Access Compliance Report

Public Rights-of-Way

(Curb Ramps)

Intersection ID: 27965	Main Street: BALLANTYNE_COUNTRY_CLUB_DR	Cross Street: POUND_HILL_LN	Location: S
ADA ID: F7570D25E2DB	Ramp Type: Perp	Initial Pass/Fail: Fail	Overall Compliance: No
			Severity Score: 1.25
Codes/Mitigation Info/Possible Solution		Field Measurements/Component Compliance

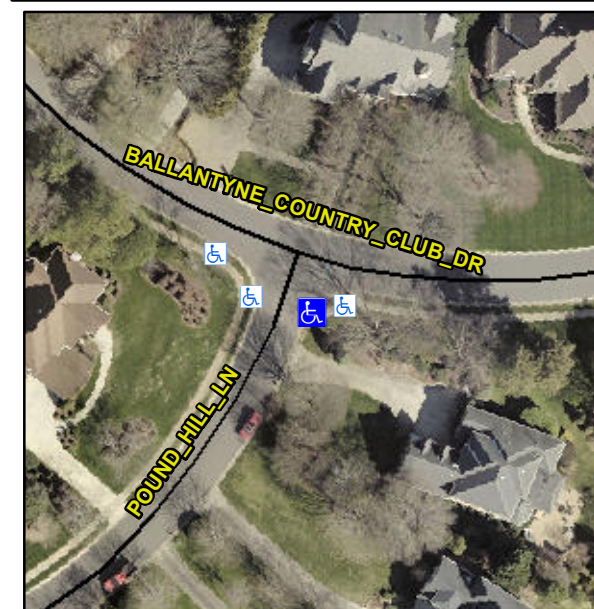
Not Found, R304.5.3

Compliance	Description	Data	Compliance	Description	Data
N/A	Ramp Length (in)	91.0	Yes	Ramp Slope (%)	7.1
Yes	Ramp Width (in)	48.0	No	Ramp XSlope (%)	3.7
N/A	Flare Type LT	N/A	N/A	Flare Type RT	N/A
N/A	Flare Slope LT (%)	N/A	N/A	Flare Slope RT (%)	N/A
N/A	Flare Traversable LT?	N/A	N/A	Flare Traversable RT?	N/A
N/A	Landing Length (in)	N/A	N/A	DWS Provided?	N/A
N/A	Landing Width (in)	N/A	N/A	DWS Contrast?	N/A
N/A	Landing Slope (%)	N/A	N/A	DWS Length (in)	N/A
N/A	Landing X Slope (%)	N/A	N/A	DWS Full Width?	N/A
N/A	Landing Curb? (Y/N)	N/A	N/A	DWS Offset (in)	N/A
N/A	Shared Landing?	N/A			
N/A	Gutter Ponding?	N/A	N/A	Gutter Slope (%)	N/A
N/A	Gutter Lip Ht (in)	N/A	N/A	Gutter X Slope (%)	N/A
N/A	Painted X Walk1?	No	N/A	Painted X Walk2?	N/A
	X Walk 1 Direction	To NW		X Walk 2 Direction	N/A
N/A	X Walk 1 Width (in)	N/A	N/A	X Walk 2 Width (in)	N/A
	X Walk 1 Slope (%)	2.7		X Walk 2 Slope (%)	N/A
	X Walk 1 X Slope (%)	1.6		X Walk 2 X Slope (%)	N/A

Remove & Replace Entire Ramp.
